GLOBAL SAFETY FIELD INVESTIGATIONS DCS5456 URGENT - DISTRIBUTE IMMEDIATELY

- Subject: A202304840-01 Service Update Camshaft Actuator Oil Control Valve Center Bolt Binding Revised service procedure, parts information, warranty information, and added floor plan.
- Models: 2020 2021 Buick Encore GX 2021 Chevrolet Trailblazer Equipped with 1.3L Turbo Engine(RPO L3T)
- To: All General Motors Dealers

Service Update A202304840 Camshaft Actuator Oil Control Valve Center Bolt Binding

Revision: 01

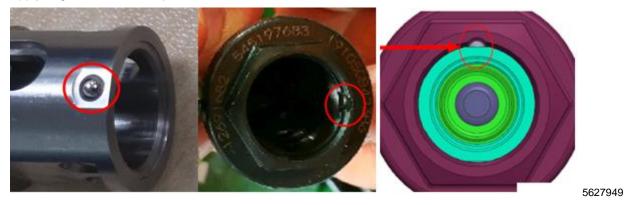
5. Remove the circlip from the end of the camshaft actuator bolt using appropriate circlip pliers.

6. Remove the camshaft actuator bolt sleeve from the bolt body using a pair of needle nose pliers as shown.

7. The removed bolt sleeve kit should look as shown – a plastic over molded sleeve.

8. Apply engine oil to the components of the new steel sleeve kit, shown above.

- 9. Install the new steel sleeve into the body of the actuator in the camshaft. Be sure to align the detent with the sleeve with the groove in the actuator body during installation (see circled areas above).
- 10. Reinstall the circlip that was removed.
 - After installing the circlip, spin the circlip using a pick to ensure it is fully seated in the slot in which it is supposed to sit.
- 11. Reinstall the Camshaft Position Actuator Exhaust Magnets. Refer to Camshaft Position Actuator Exhaust Magnet Replacement in SI.
- 12. Reinstall the Engine Control Module Bracket. Refer to Engine Control Module Bracket Replacement in SI.
